#### REMARKS

#### Claim Rejections - 35 USC §103

Amendments To Claims and Drawing

Fig.2

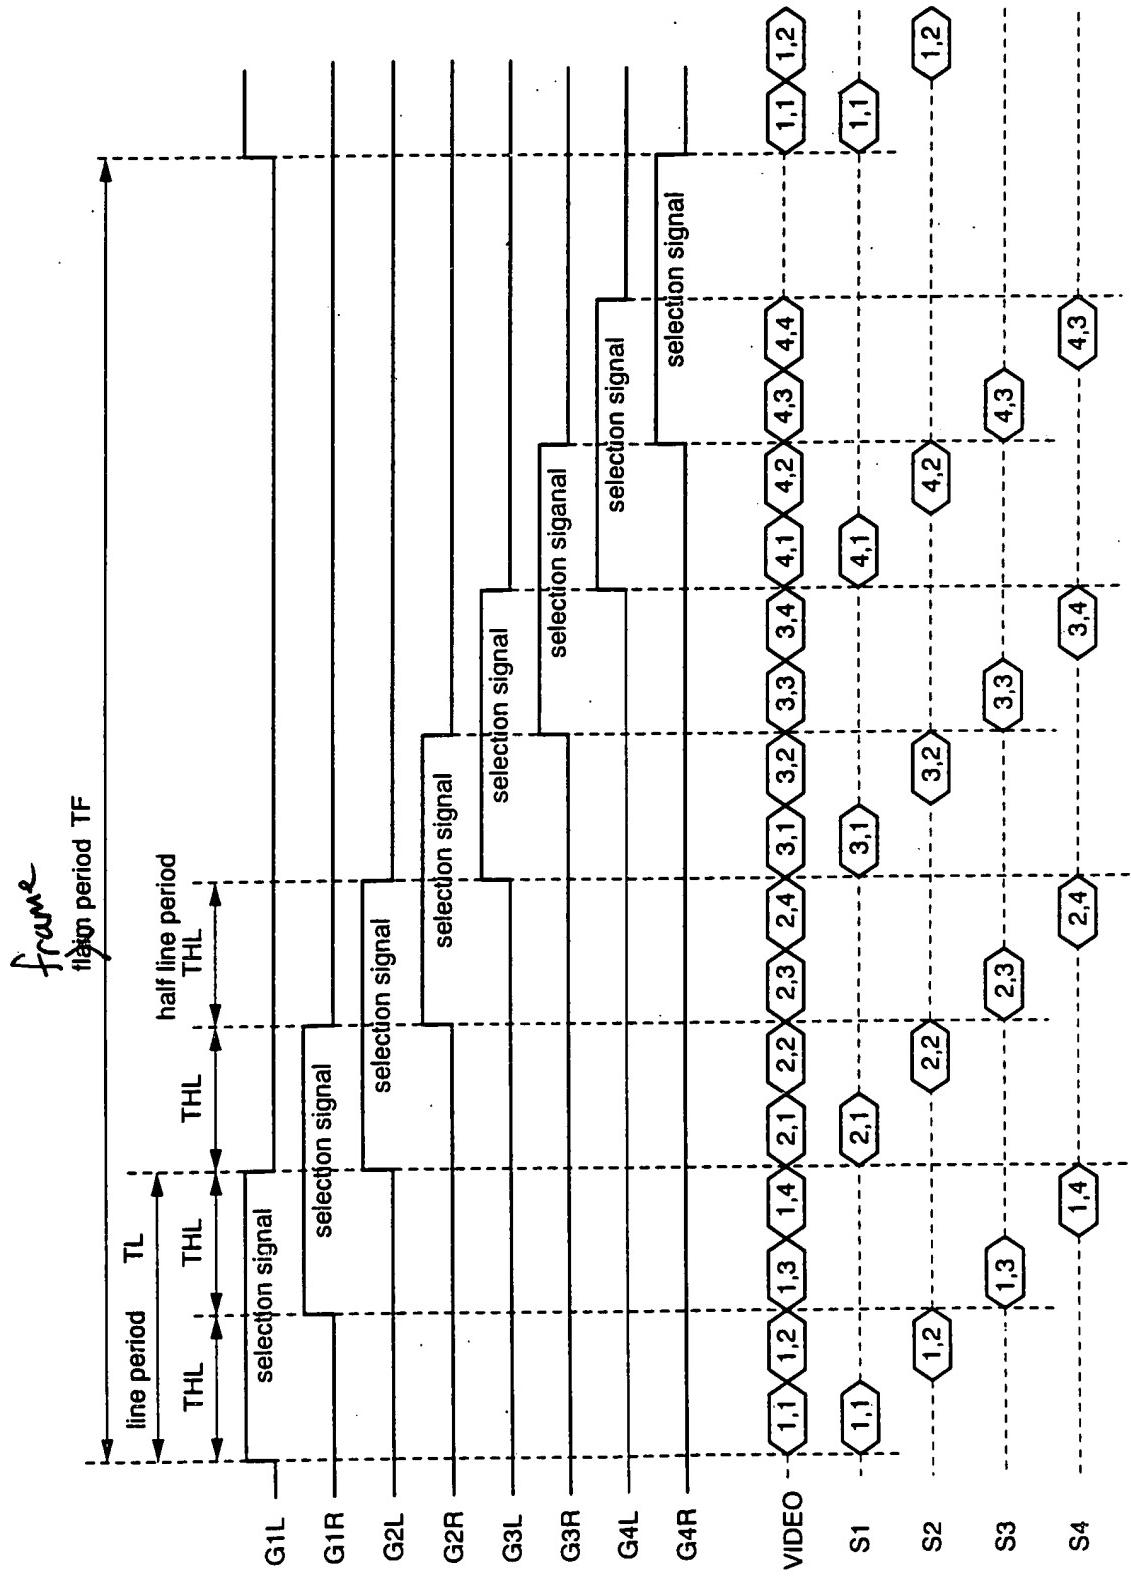
Figure 2 is also being amended to correct a clear typographical error.

Please amend the attached figure as shown in red.
